OCTOBER 9, 2025

BOARD OF COMMISSIONERS REGULAR PUBLIC MEETING

**RE: Executive Summary for LD-25-01 – 1526 Fairview Avenue
PARID: 30-00-18860-00-1/ TMID: 30196 017
Preliminary/Final Major Subdivision & Land Development Plans Review (2nd Submission)**

RE: LD-25-01 – 1526 Fairview Avenue
PARID: 30-00-18860-00-1/ TMID: 30196 017
Preliminary/Final Major Subdivision & Land Development Plans Review (2nd Submission)

STORMWATER PLAN AND PROFILE

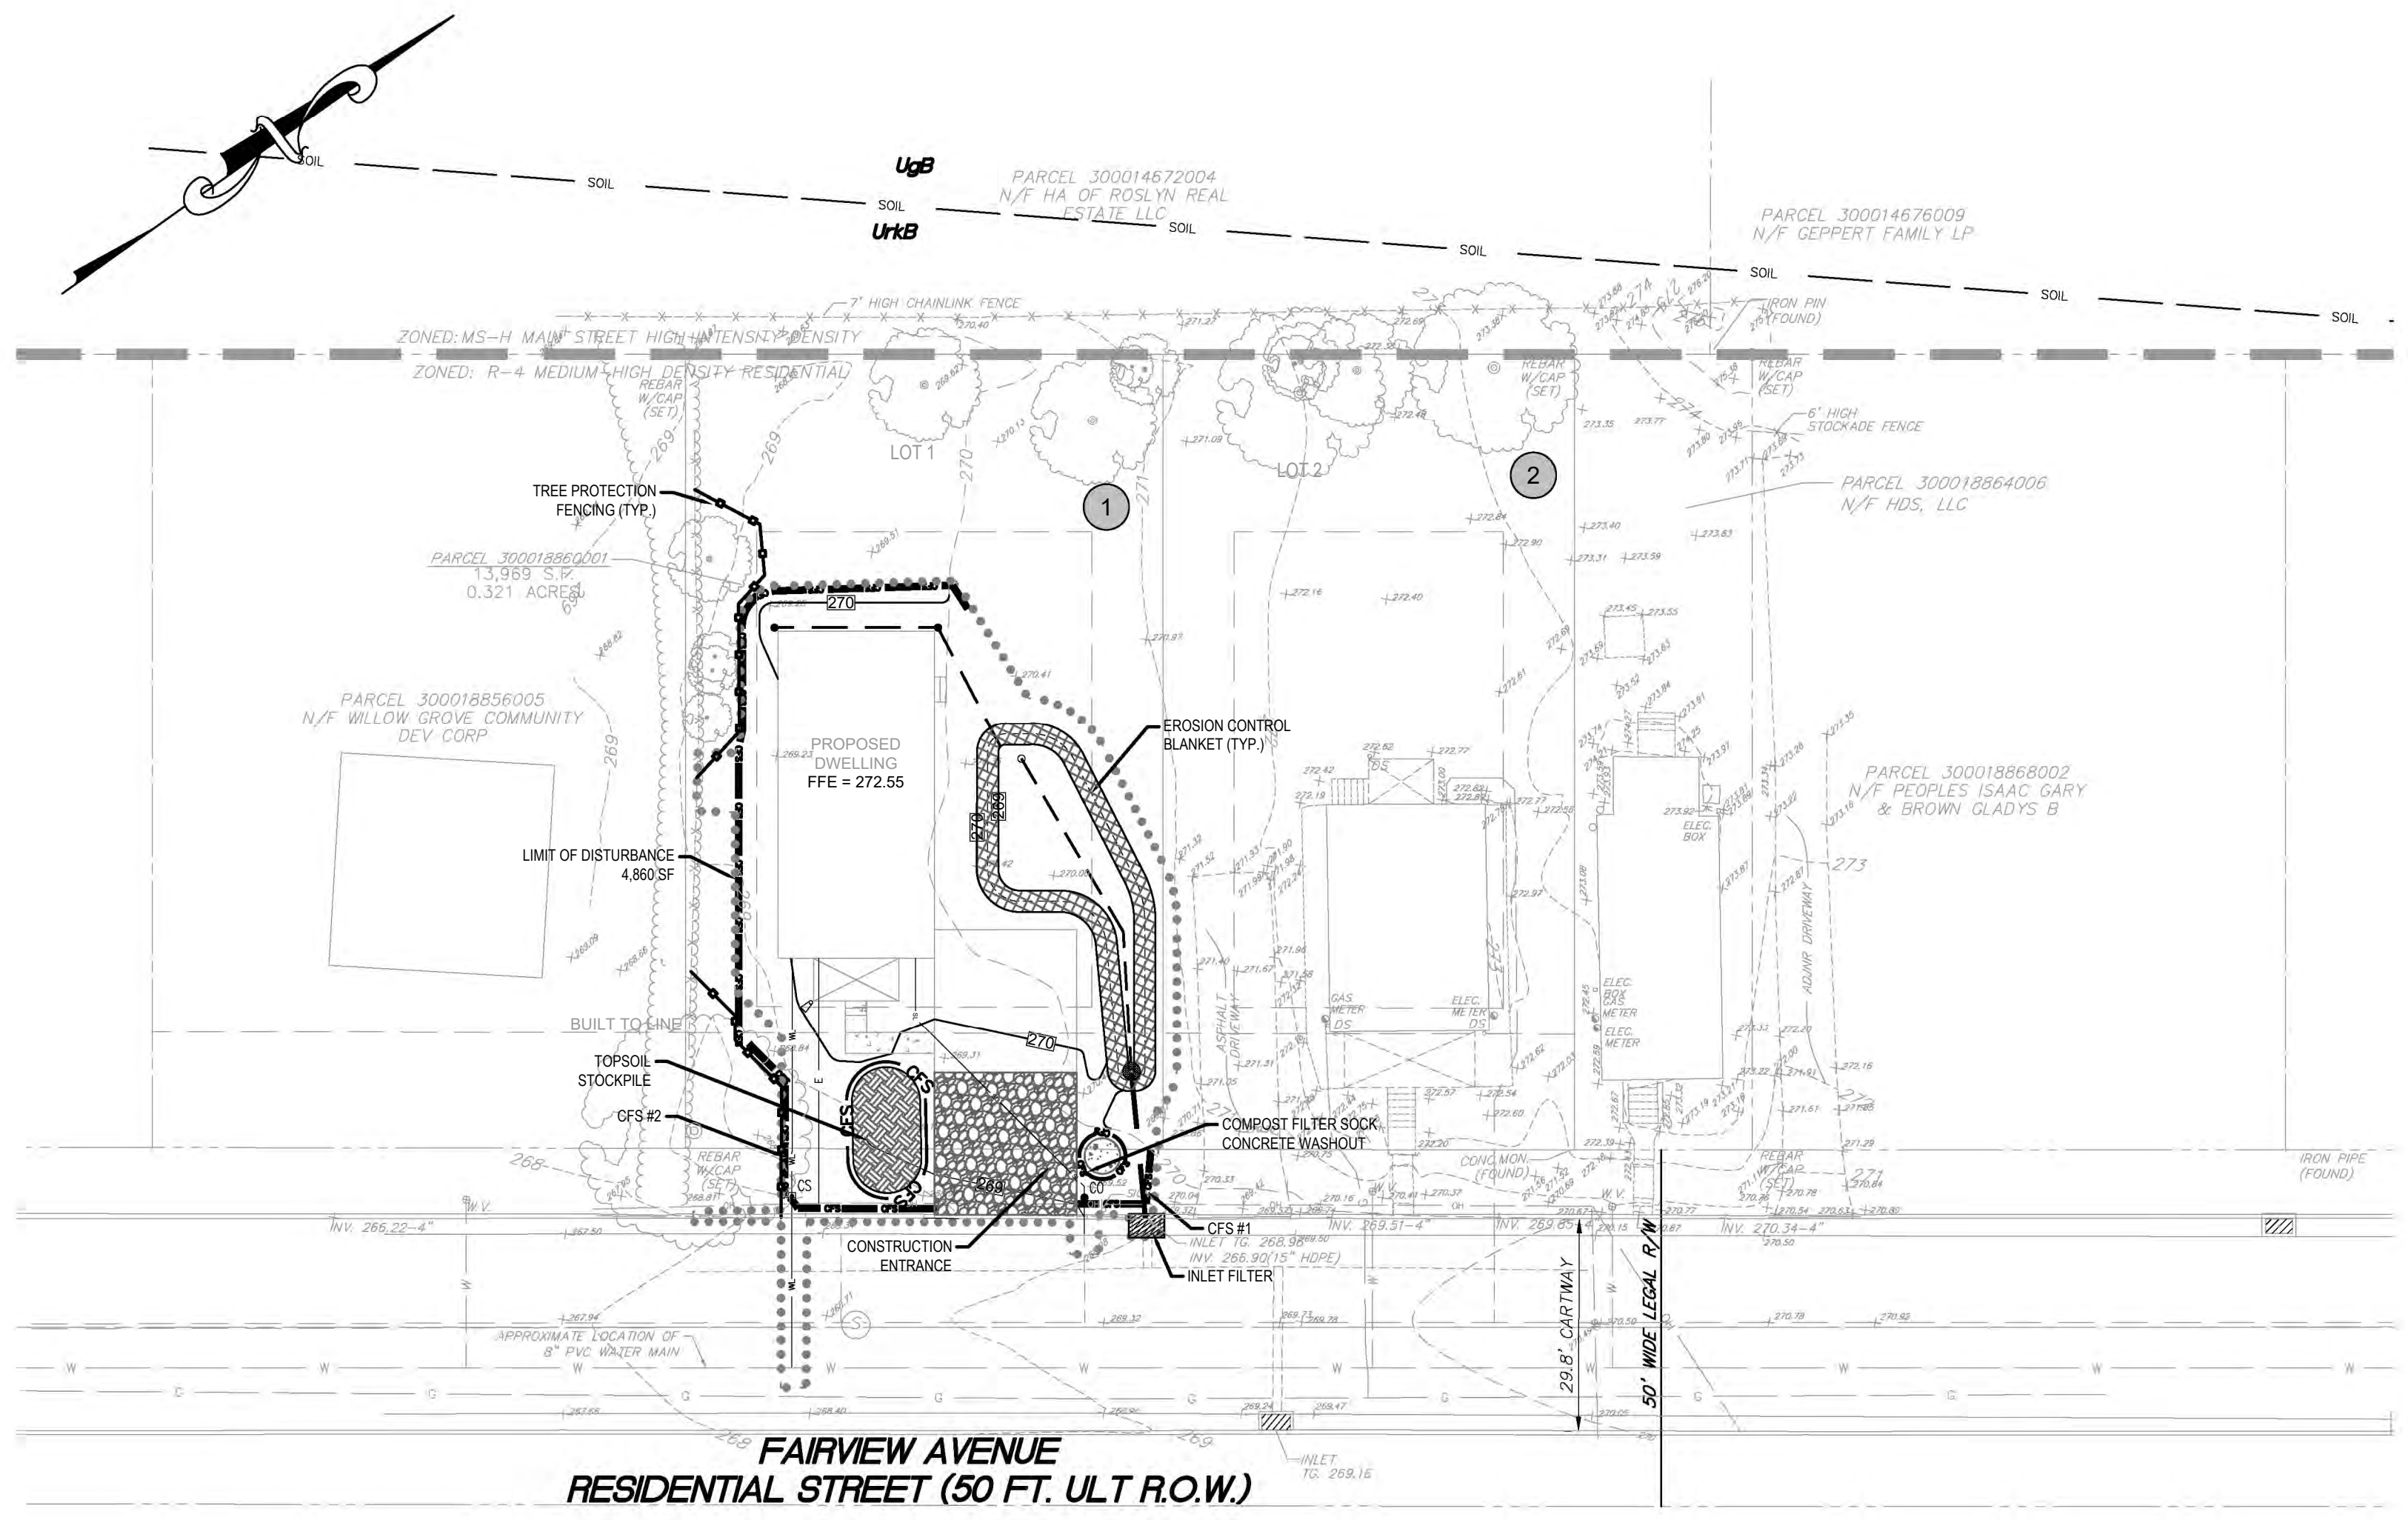
An O&M schedule and notes shall be provided on the Stormwater Plan (Sheet 5) for the proposed raingarden facility.

Township of Abington
STANDARD DETAIL - SEWER SYSTEM
TYPICAL BUILDING SEWER CLEANOUT ASSEMBLY

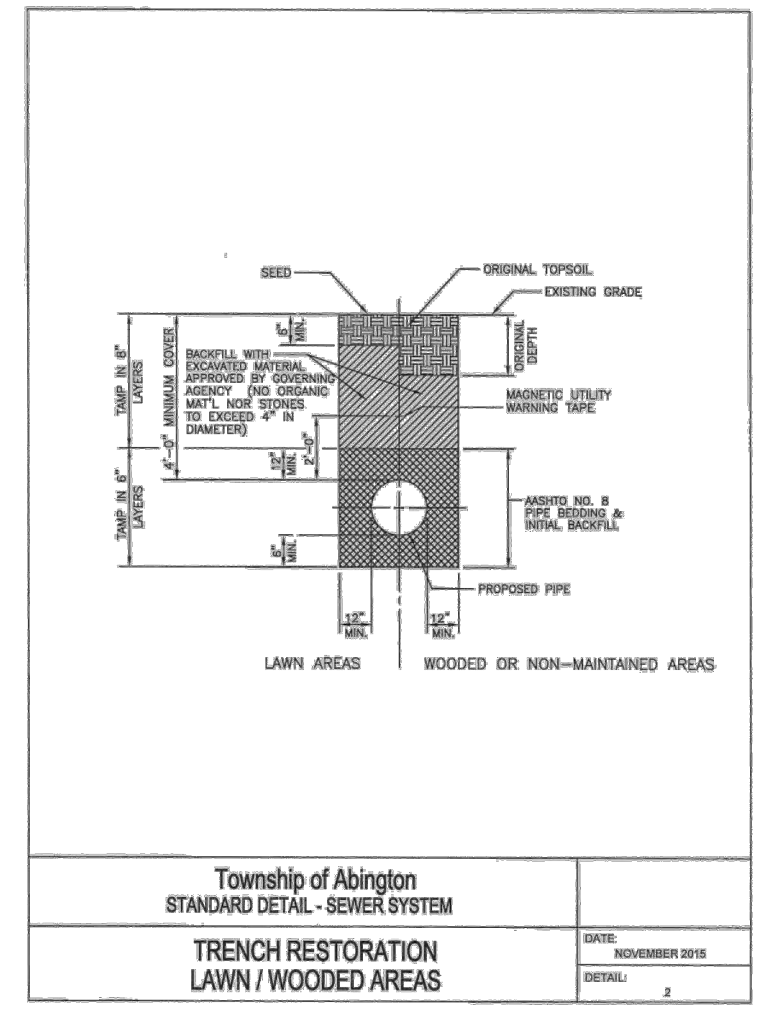
- The "Typical Cleanout Detail (Paved Areas)" and the "Typical Cleanout Detail (landscape Areas)" should be removed from the plans and replaced with the Township of Abington Typical Building Sewer Cleanout Assembly which utilizes a 2-way cleanout tee fitting. The proposed cleanout adjacent to the driveway apron should also be protected by a cleanout frame and cover assembly which should be added to the Construction Details Sheet. Also, the Township of Abington Trench Restoration Lawn/Wooded Areas should be added to the Construction Details Sheet.

OUTLET CONTROL STRUCTURE
NOT TO SCALE

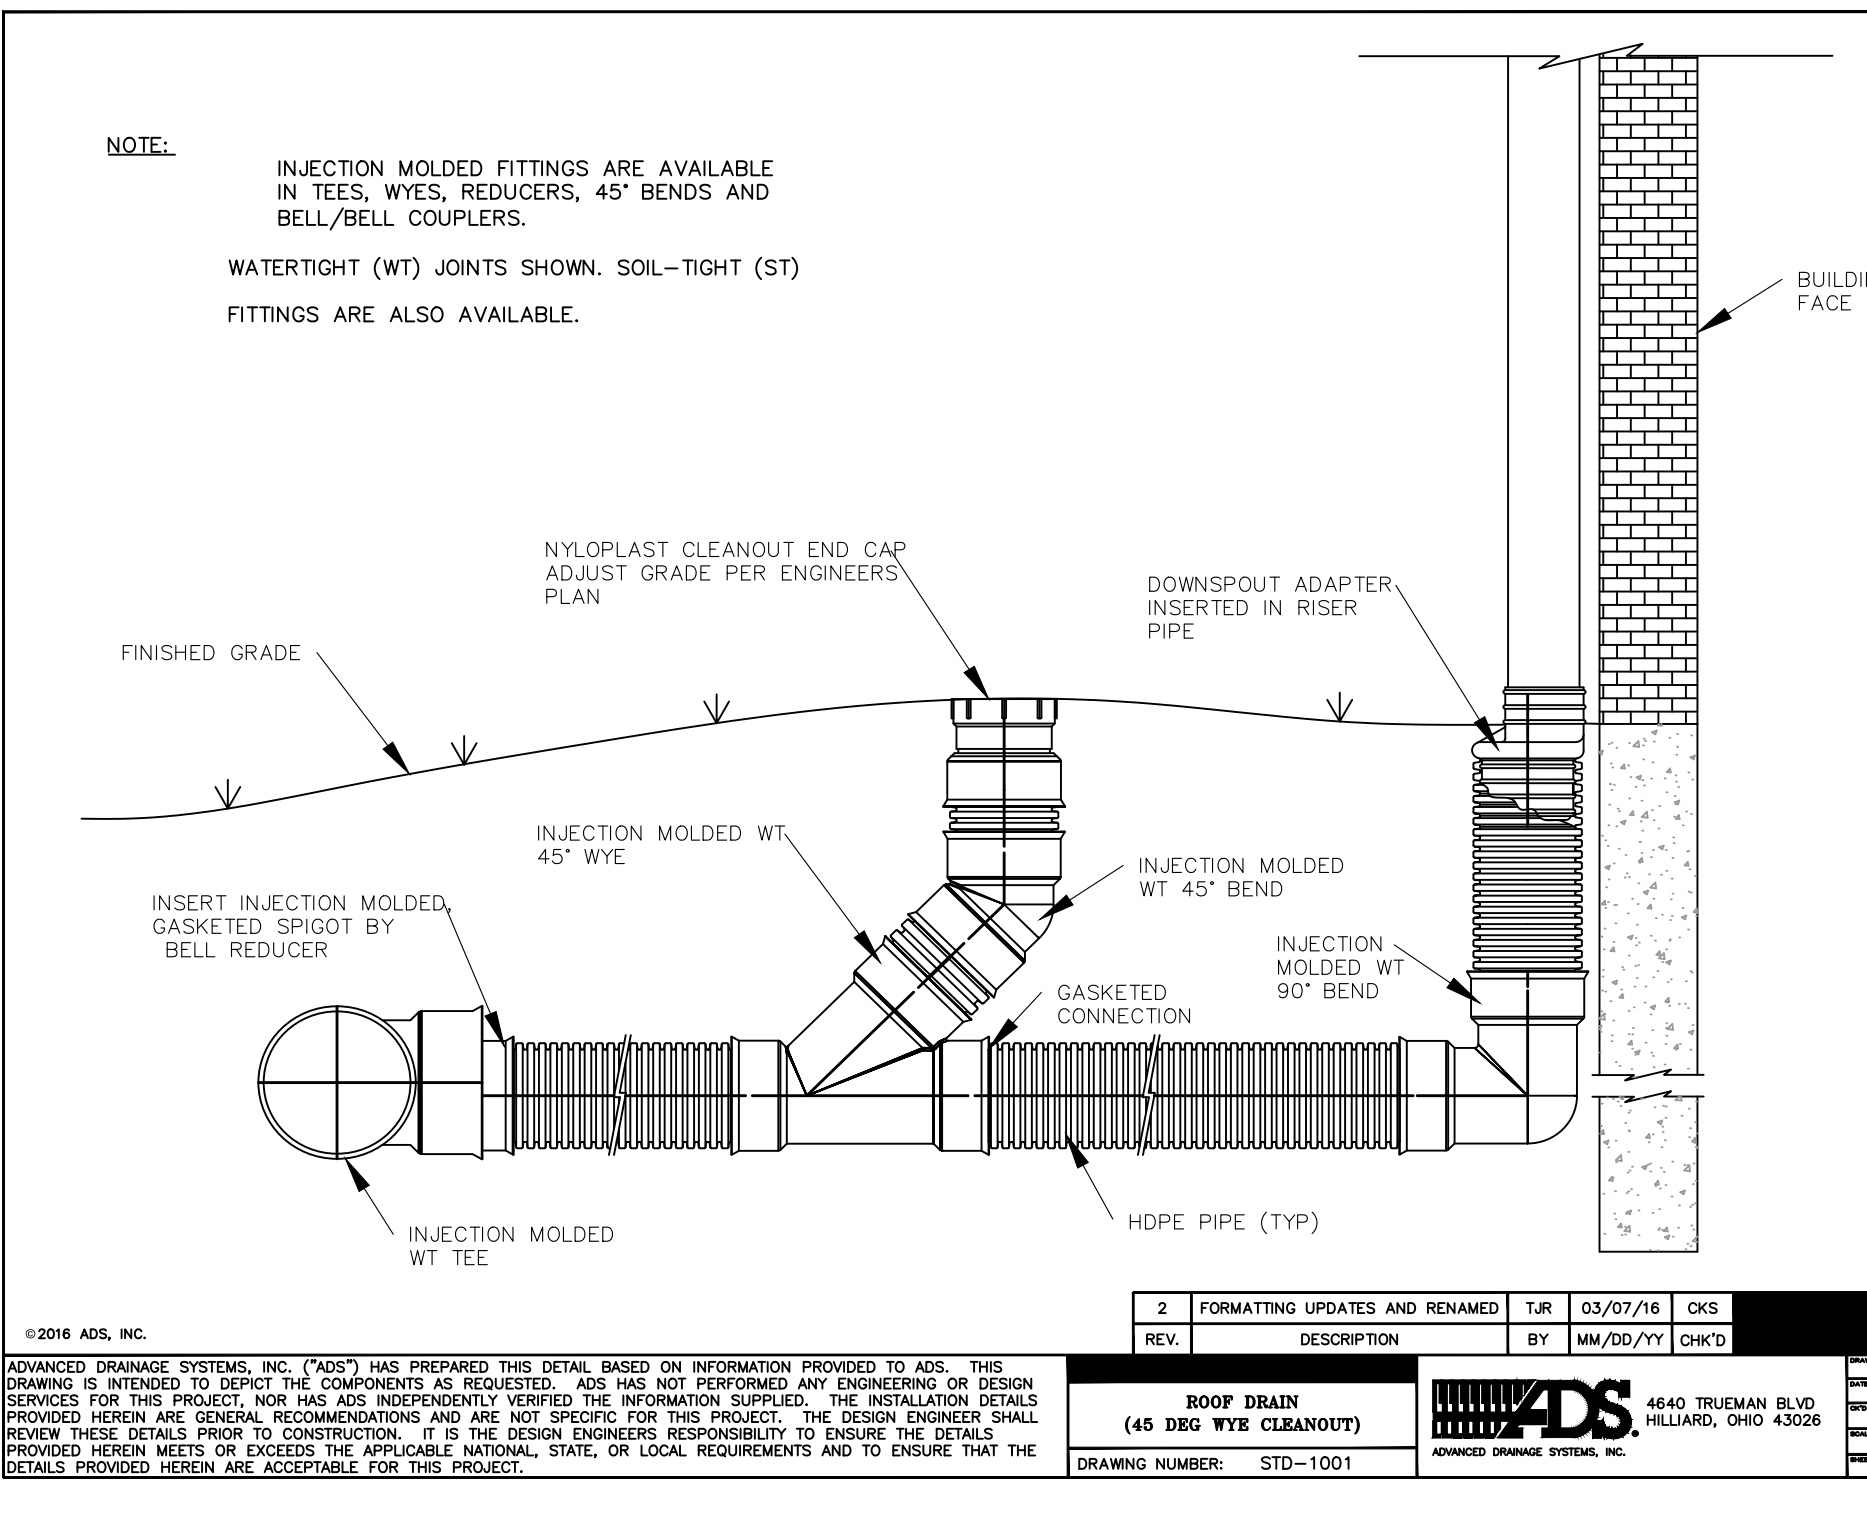
- Add flow dissipator or rip-rap apron for the downspout discharge pipe into the raingarden.
 - On the Outlet Control Structure Detail provided on the plans, the inlet pipe is labeled as 15"; however, on the plans, the inlet pipe is a 4" perforated pipe. The detail shall be revised accordingly.
